BID PACKAGE 01 – ADDENDUM 01

Re: Wilma P Mankiller Health Center Expansion

Bid Package 01- Addendum 01 – Wilma P. Mankiller Health Center Expansion

Chavez-Grieves would like to incorporate the following revisions into the drawings for the above referenced project.

SHEET NUMBER: S0.03

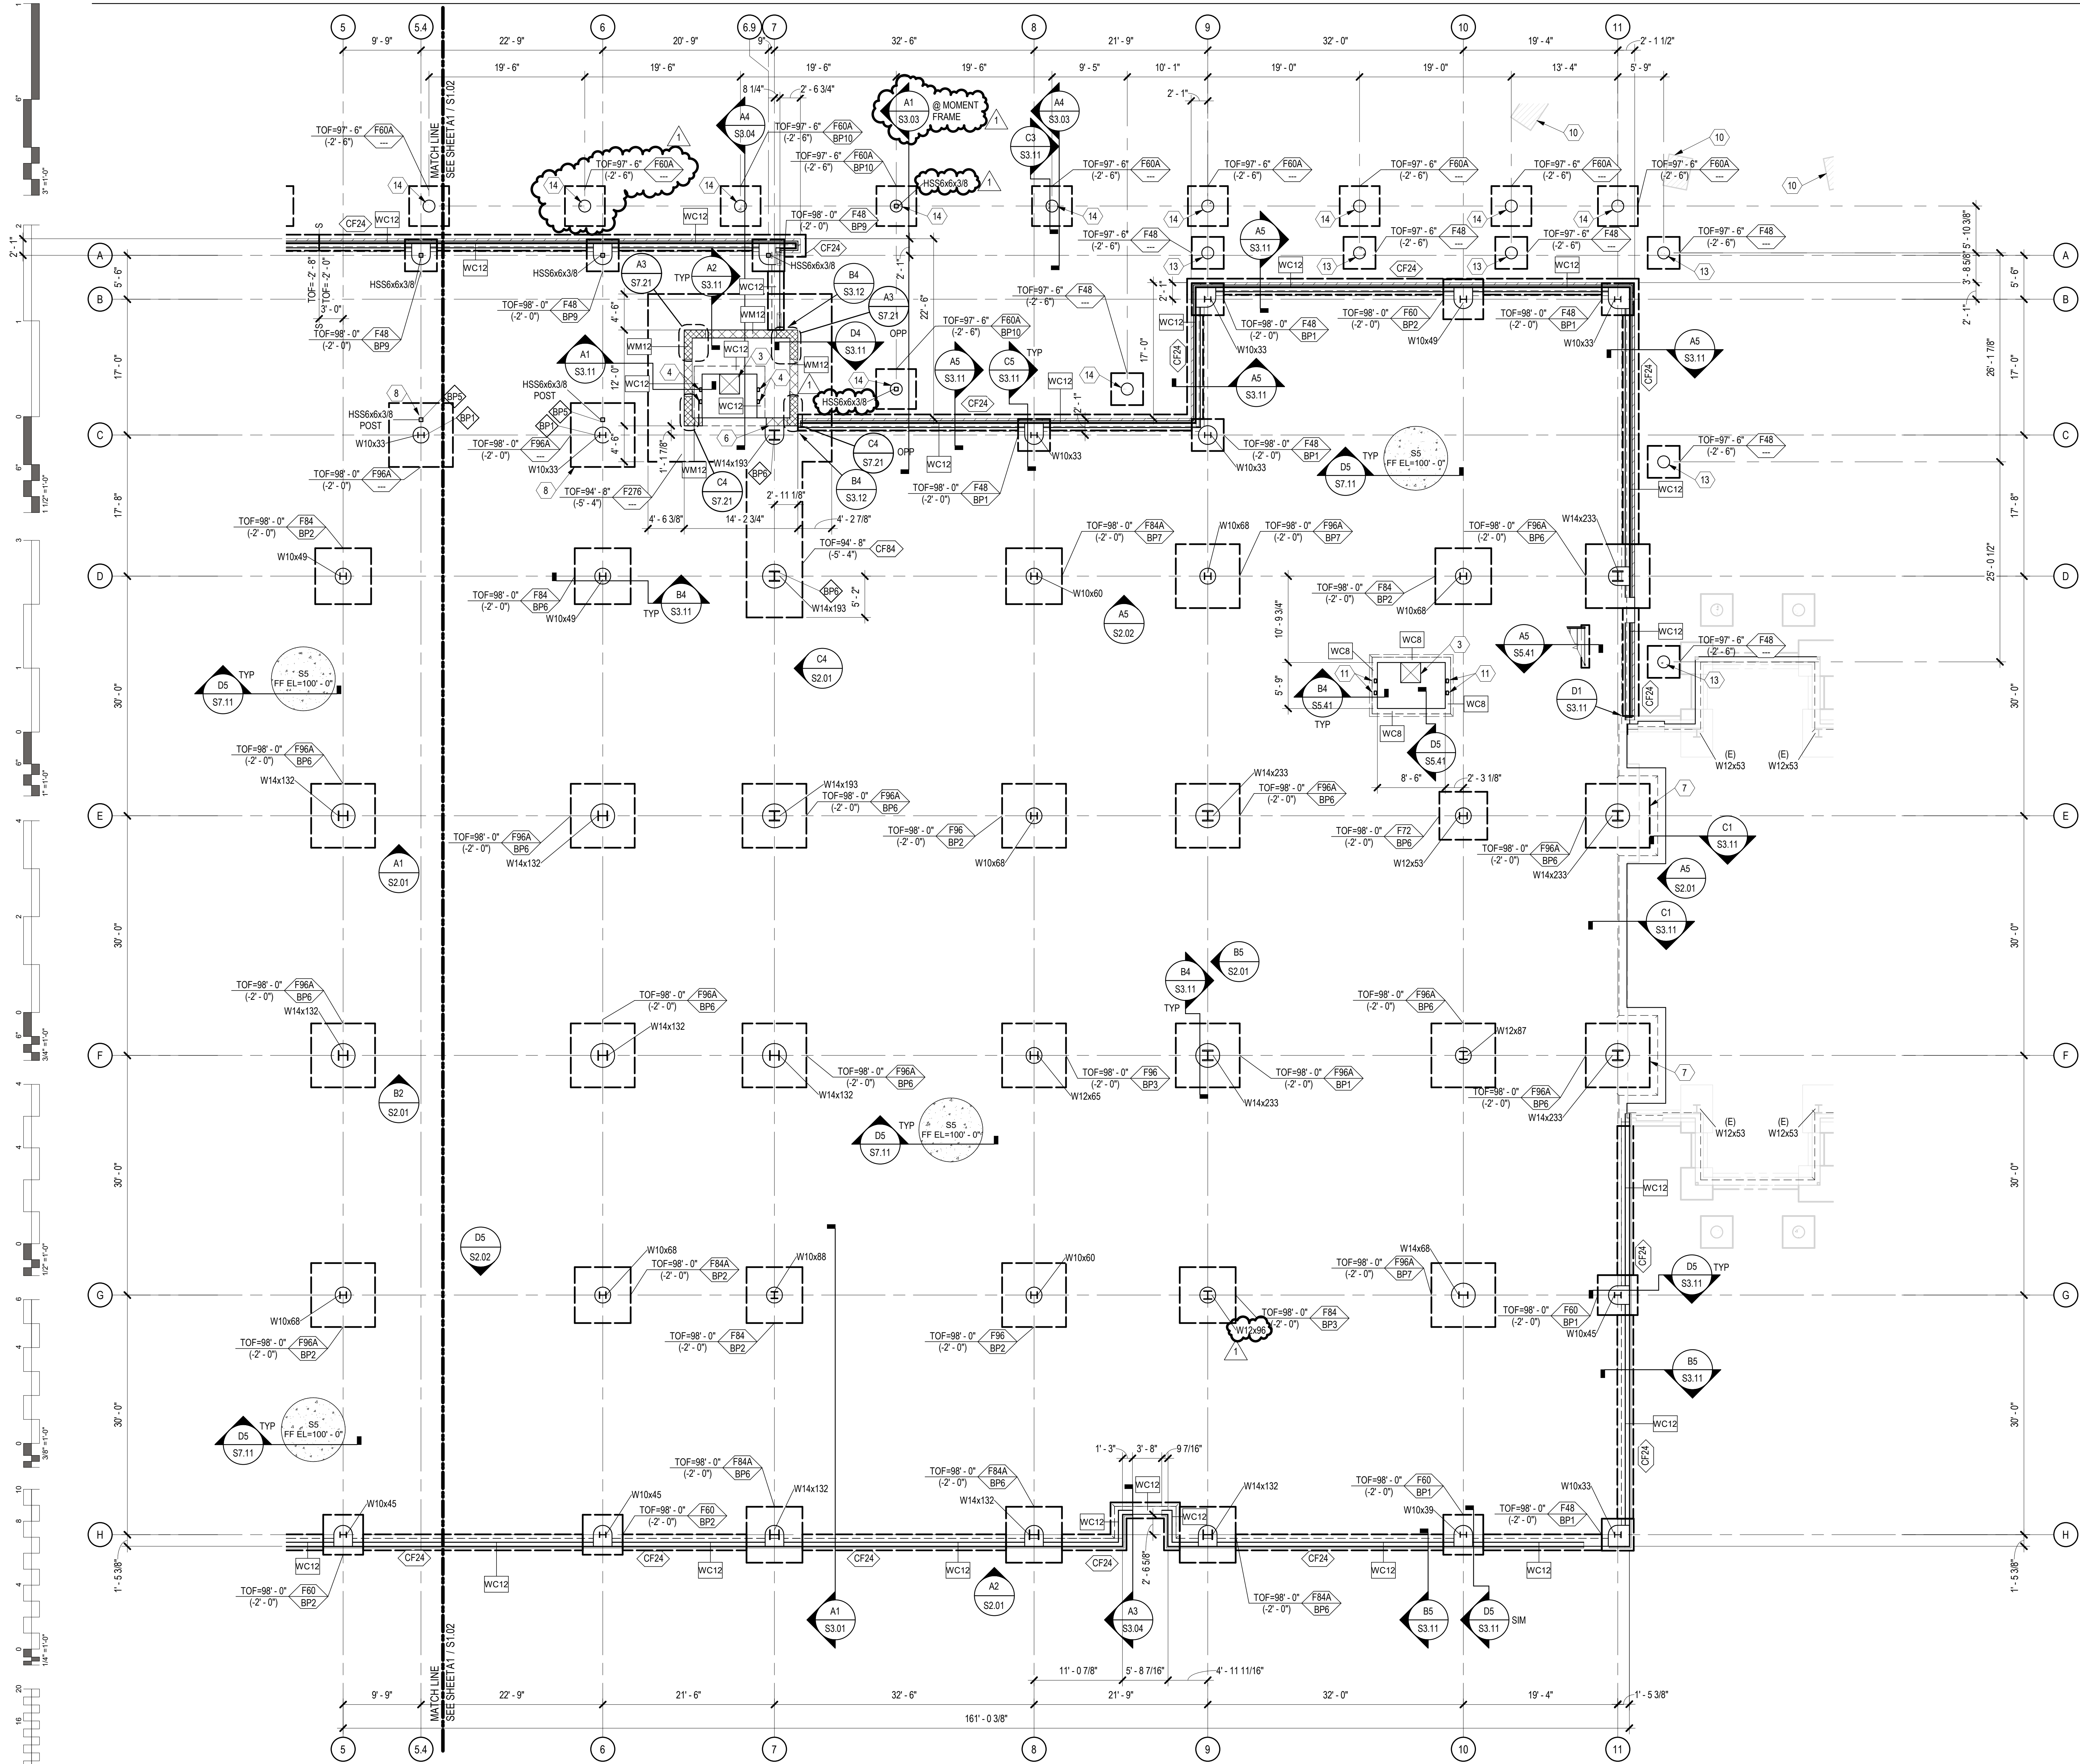
<u>Sheet</u>	<u>Description</u>
S0.02	Revised floor loading information.
S0.03	Revised wind loading diagram.
S1.01	Sheet keynotes 6, 13, and 14 revised.
S1.01	Column size at Grid G/9 revised.
S1.01	Sections added at canopy near Grid A/7.
S1.01	Column and spread footing sizes updated at canopy near Grid A/7.
S1.02	Canopy footings and column sizes revised near Grid A/4.6.
S1.11	Column size at Grid G/9 revised.
S1.11	Beam along Grid 10, between Grids G and F updated.
S1.11	Beams between Grids 9 and 11, near Grid D updated.
S1.11	Pilaster tags added to masonry shaft wall.
S1.11	Canopy/lobby area top of steel elevations added near Grids A and C.
S1.11	Canopy/lobby area details and sections added near Grids A and C.
S1.11	Canopy/lobby area clarifying dimensions added near Grids A and C.
S1.12	Canopy/lobby area top of steel elevations added near Grids A and C.
S1.12	Canopy/lobby area details and sections added near Grids A and C.

SHEET NUMBER:
S1.13
LOW ROOF FRAMING
PLAN

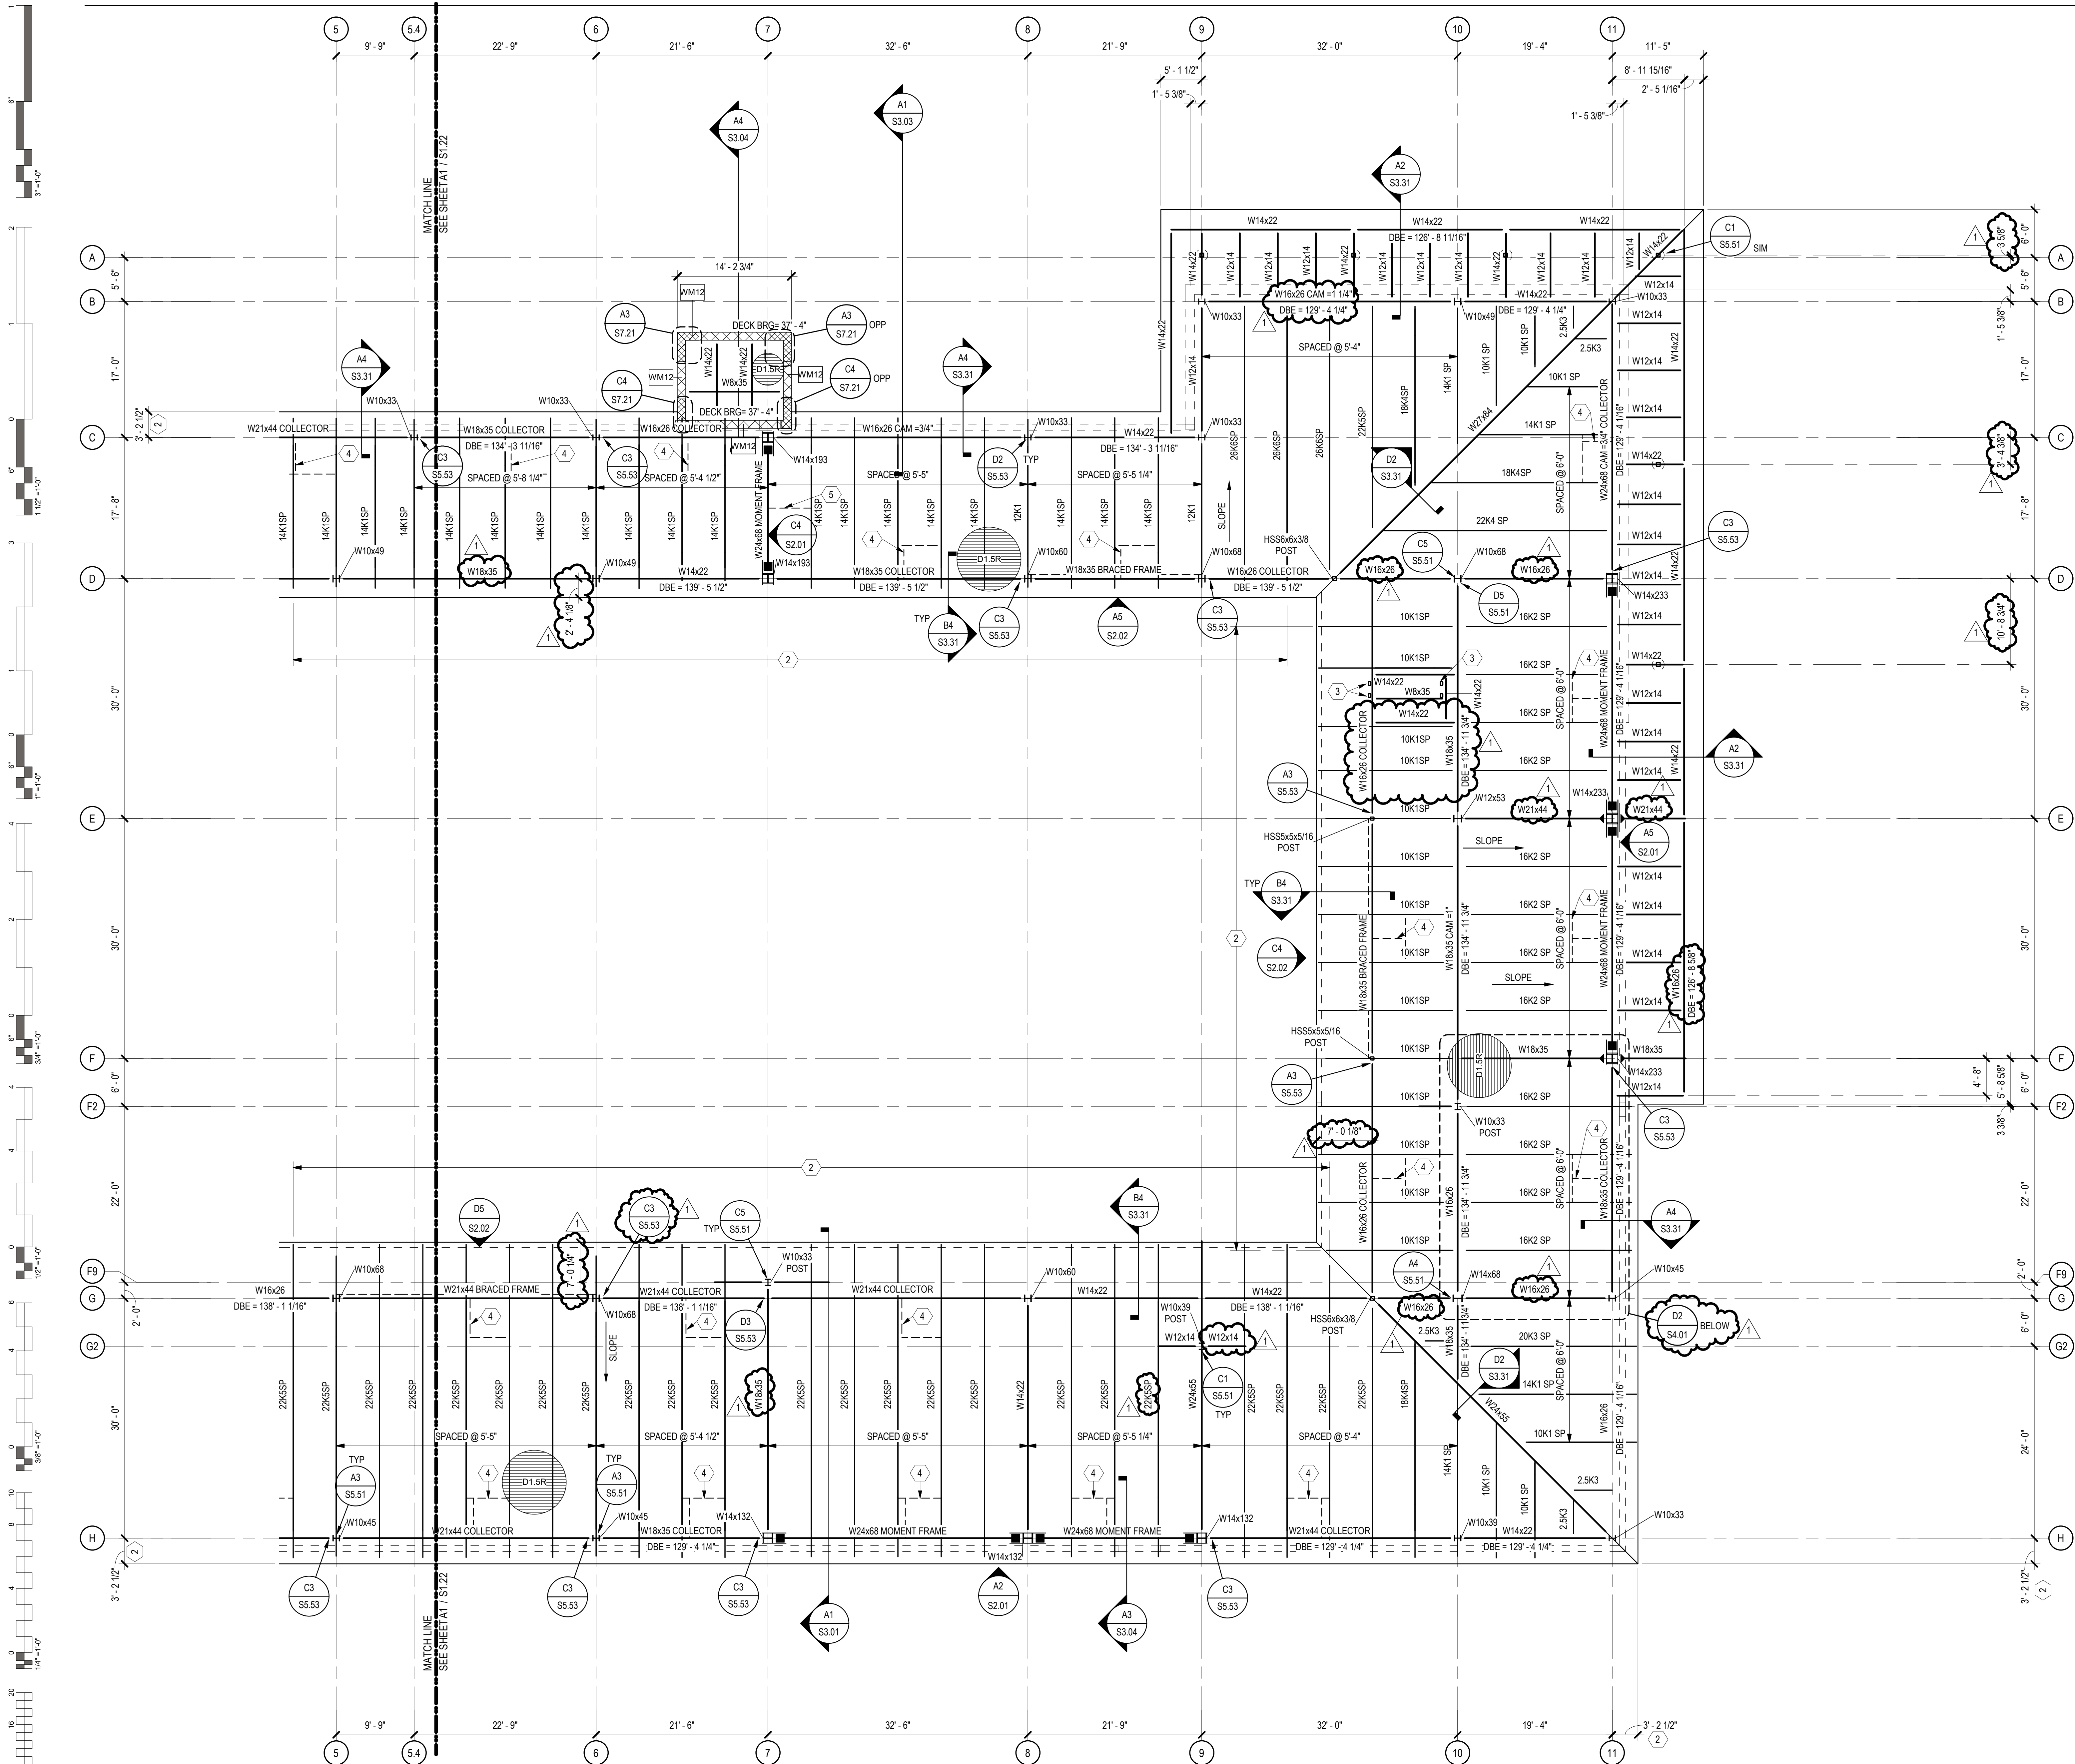
S1.12	Canopy/lobby area clarifying dimensions added near Grids A and C.
S1.12	Operable partition support beam sizes updated near Grid D, between Grids 1 and 2.
S1.12	Detail D3/S5.53 added near Grid H/2.
S1.13	Sheet keynote 12 revised.
S1.13	Snapping point between Grid E and D corrected.
S1.13	Beams/girders supporting rooftop mechanical units revised.
S1.13	Framing between Grid G/8 and F/10 revised.
S1.13	Connection details at Grid G/4 and D/7 revised.
S1.13	Beam removed and bottom flange bracing (keynote 8) added to moment frame beam at Grid F/3.
S1.13	Connection details updated at Grids E/4, E/6, D/7, and F/5.
S1.13	Bottom flange bracing (keynote 9) added to girders along Grid F and E, between Grids 4/5 and 6/7, respectively.
S1.13	Beam/bottom flange bracing added at post near Grid G/7.
S1.21	Clarifying dimensions and sections added around interior and exterior roof perimeter.
S1.21	Location of enlarged framing plan tag D2/S4.01 adjusted.

SHEET NUMBER:
S1.21

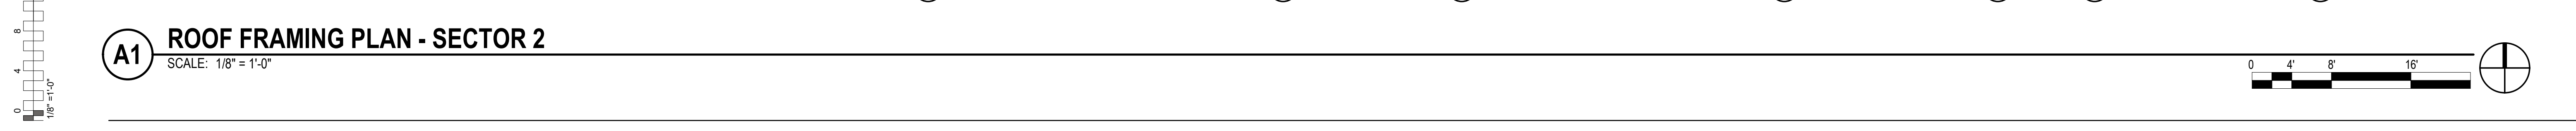
S1.21	Beam sizes near Grid G/11 revised.
S1.21	Beams added near post at Grid G2/9.
S1.21	Beam sizes near Grid E/11 revised.

S1.21	Beam sizes near Grid D/11 revised.
S1.21	Beam details revised at Grid B/9 and D/6.
S1.22	Sheet keynote 7 added.
S1.22	Clarifying dimensions and sections added around interior and exterior roof perimeter.
S1.22	Bottom flange bracing (keynote 4) added along Grids D and G.
S1.22	Joist size updates made along Grid 1, between Grids G and E.
S1.22	Beam size updates made near Grid E/1.
S2.01	SidePlate sheet numbers added to elevation key.
S3.03	Section A1 revised.
S3.11	Sections C3 and D2 revised.
S3.12	Section C4 added.
S3.31	Sections A5, B3, B4, D5, and D2 revised.
S3.31	Sections A1 and B1 added.
S4.01	Plans A3, D2, and D4 revised.
S5.21	Detail D5 revised.
S5.52	Details A5 and B5 revised.
S5.53	Detail C3 revised.
S5.54	Sheet added.
S6.01	Footing F60A information revised.
S6.01	Baseplate schedule information revised.
S6.01	Deck schedule information revised.
S6.01	Masonry opening information revised.
S7.21	Details A3 and D4 revised.
